DEWHURST & PARTNER LTD
MELBOURNE WORKS HOUNSLOW

TITLE -
SCHEME FOR MCC 5A - SEAFORTH GRAIN TERMINAL

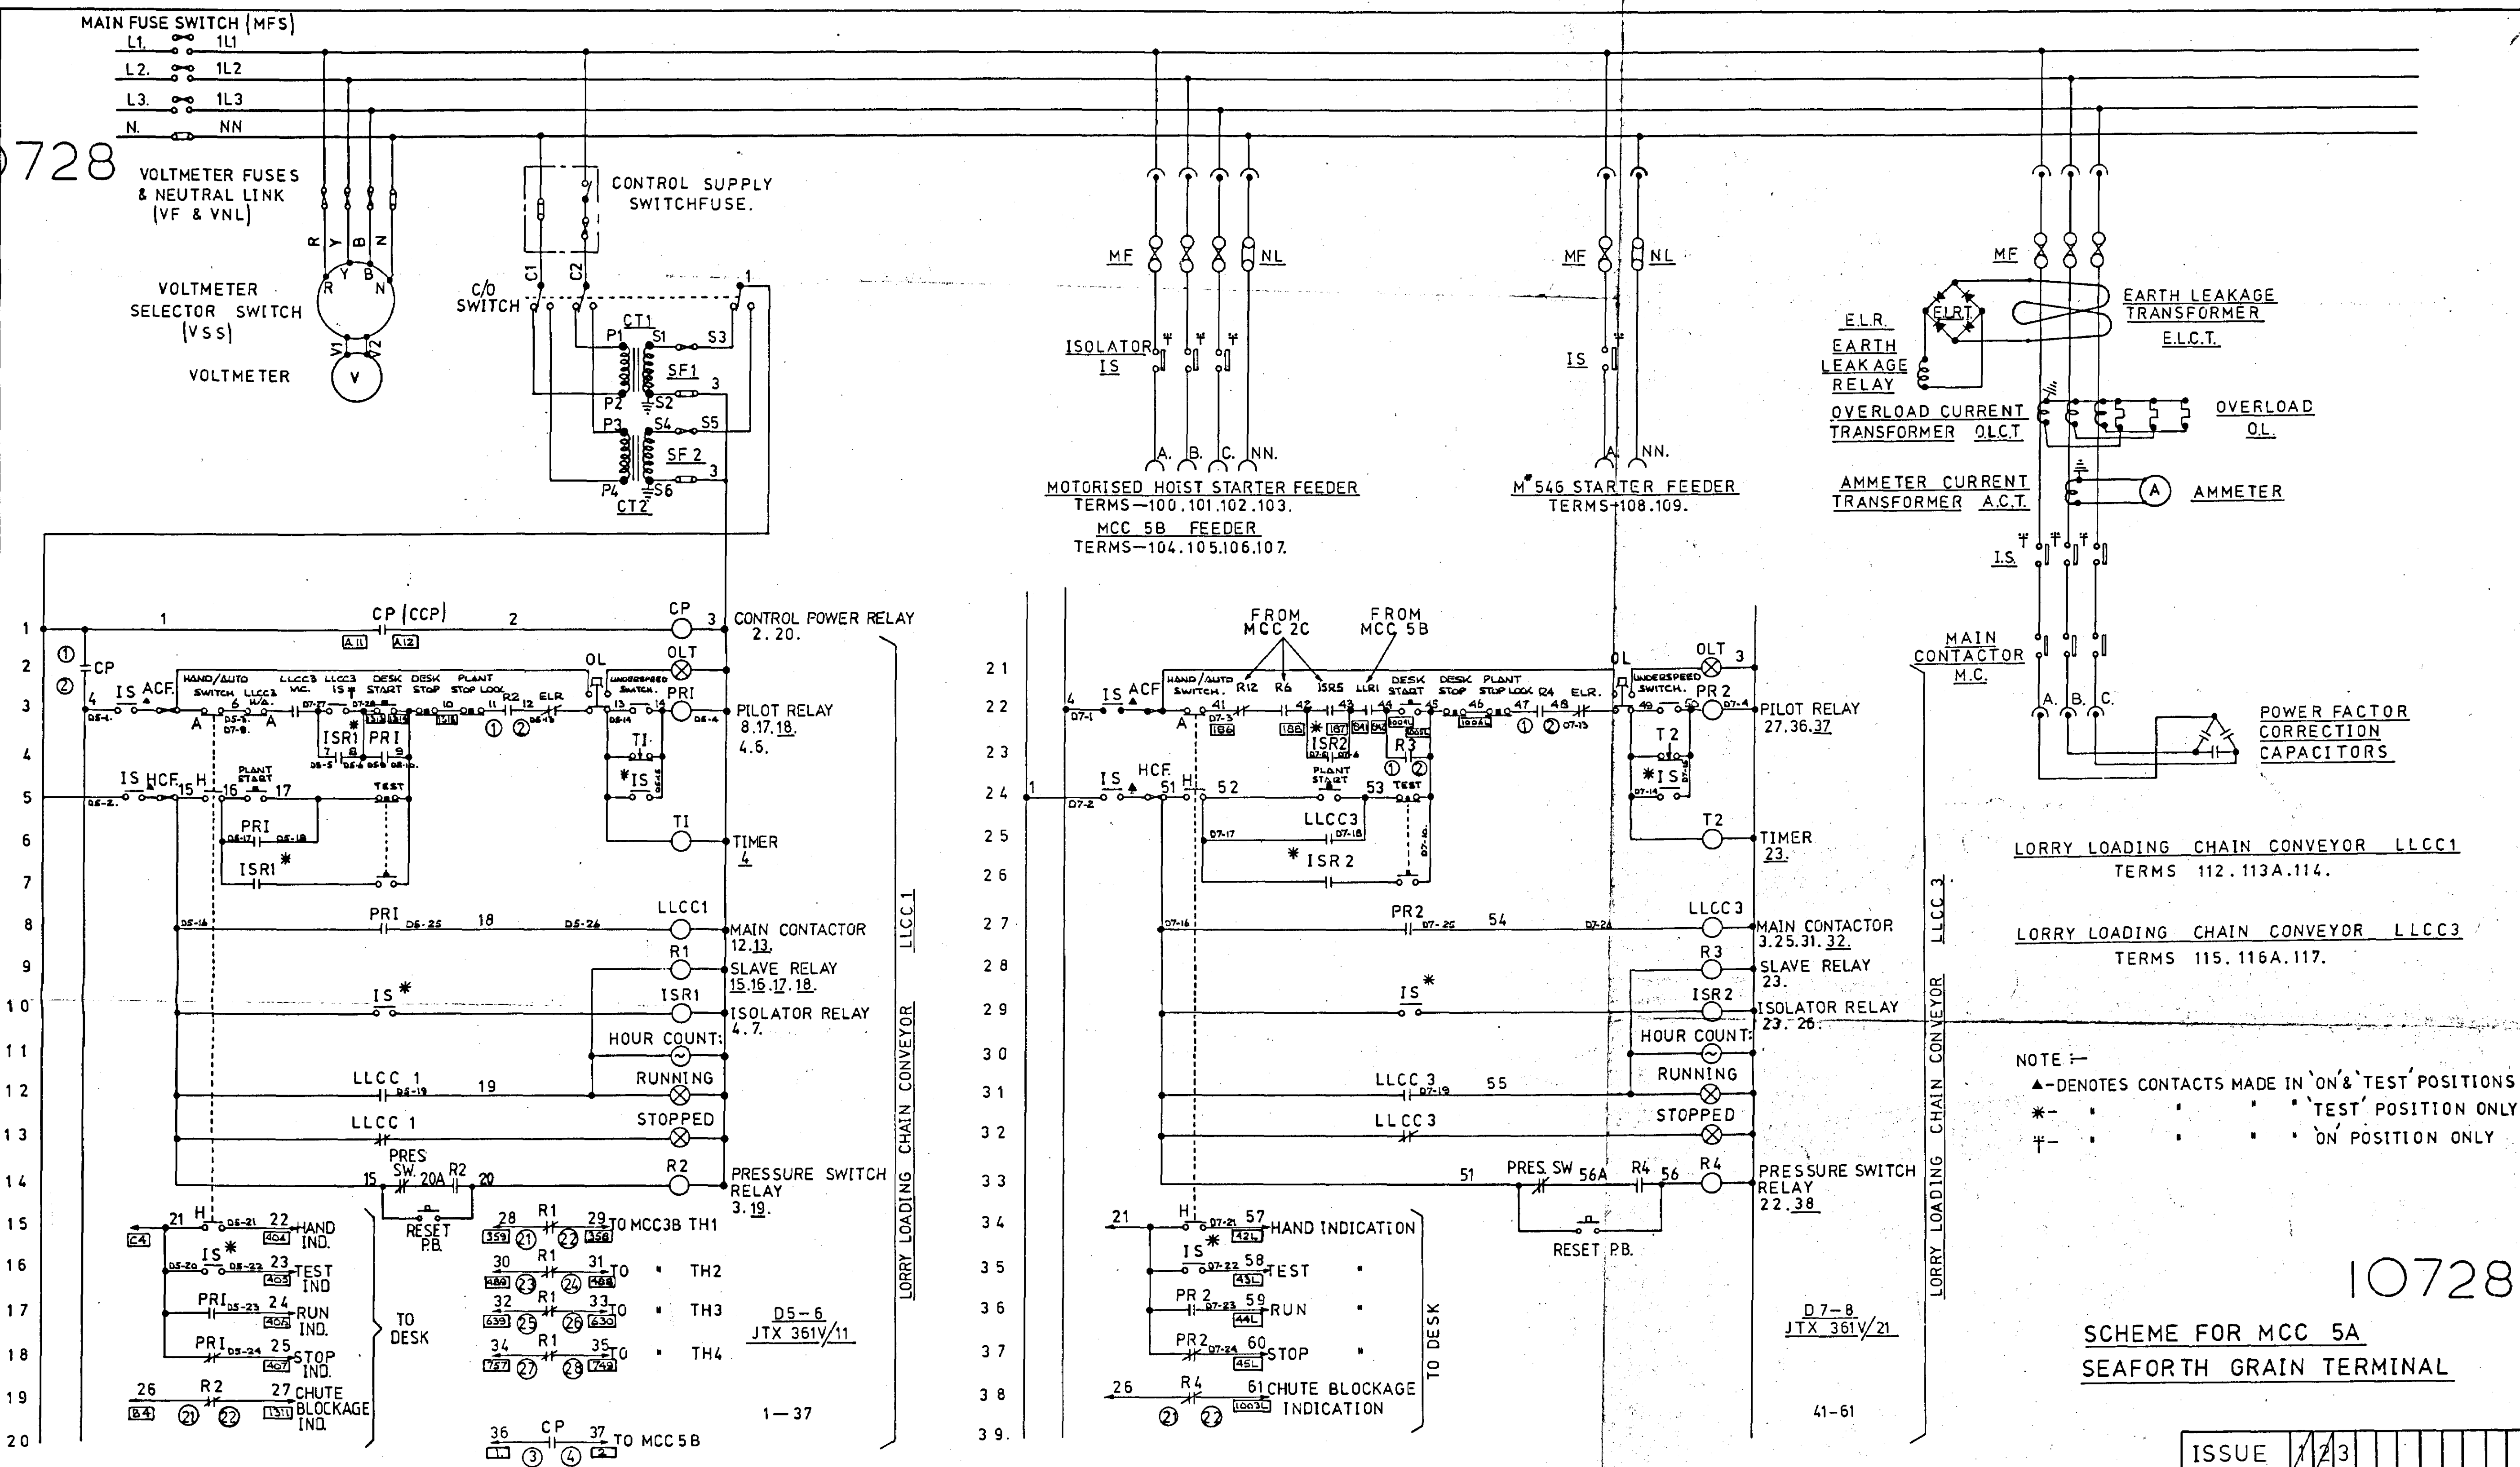
REVISION 3 Line 14: R2 contact & reset PB added Line 39: R4 contact & reset PB added 14-7-81 R.H.M.	REVISION 2 R1 & R2 WERE ACROSS MAIN CONT. COILS 27-5-71	REVISION 1 LLCC1 SUSTAINING CONTACTS WERE ON M.C. 20-4-71	DRAWN BY DATE 16-3-71 CHECKED BY APPROVED BY DATE	KEY: DIA. N° EXT. DIA. N° RTX 361 AD REL. DIA. N° PANEL LAYOUT. GTX 361 AD
--	---	---	---	---
